SAN JACINTO RIVER WASTE PITS TIME CRITICAL REMOVAL ACTION REPORT ON REASSESSMENT OF DESIGN AND CONSTRUCTION

U.S. Environmental Protection Agency, Region 6

April 2013

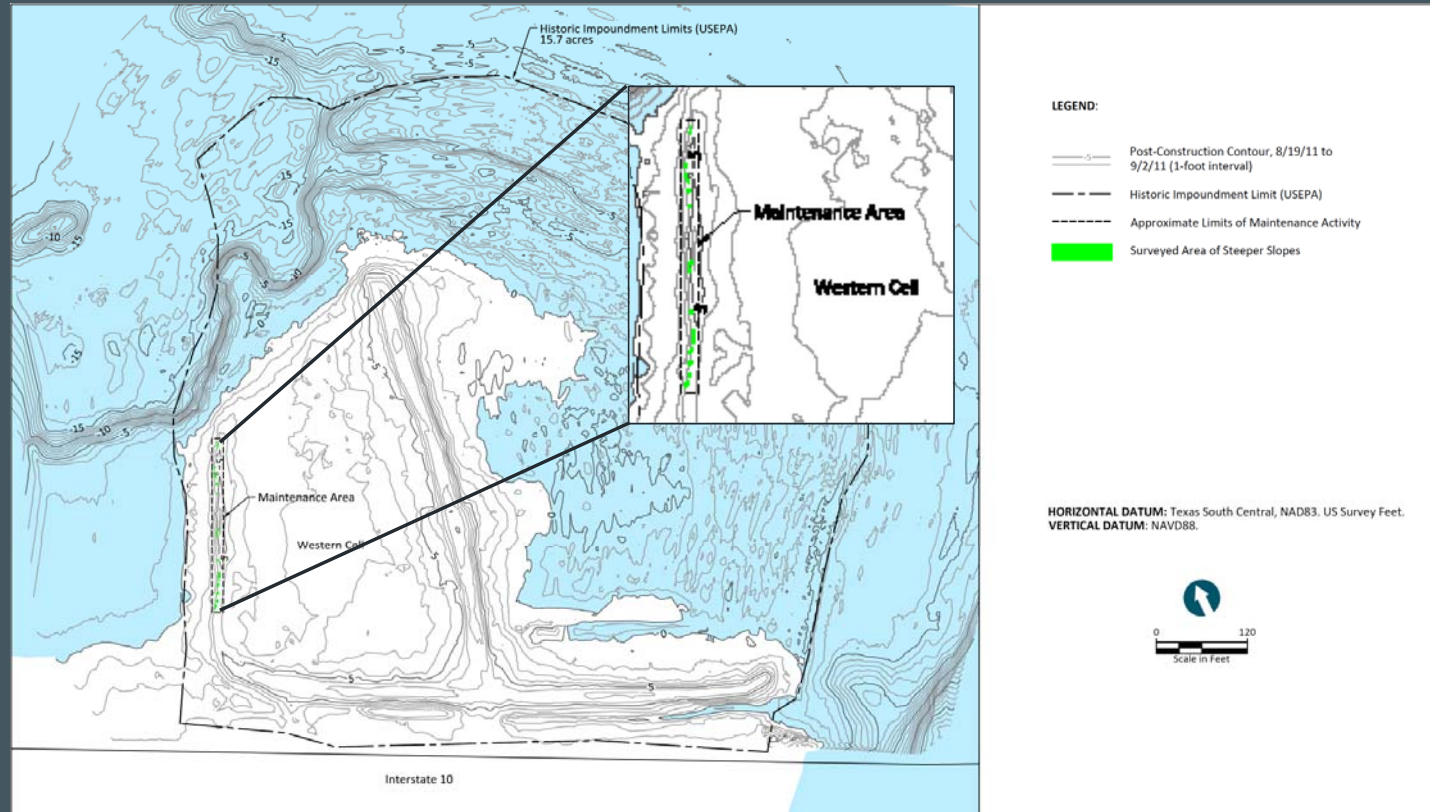
Question 6 - What was the original slope of the Armor Cap B/C material placed on the western berm? Did the original slope placement contribute to the strength or instability of the western berm?

Answer 6 - The outside slope of the armor was designed to be constructed to a grade of 2H:1V or flatter. Based on post-construction survey and visual inspections, the finished grade armor rock covered the western berm at 2H:1V or flatter over larger scales.

The survey data and visual inspection showed the design slopes of 2H:1V were achieved. Areas were identified during the repair activity planning for the western berm using detailed topographic survey techniques and showed small scale slopes that were steeper than 2H:1V along the western berm. The total area with those steep slopes was about 80 square feet and is shown on the following slide.
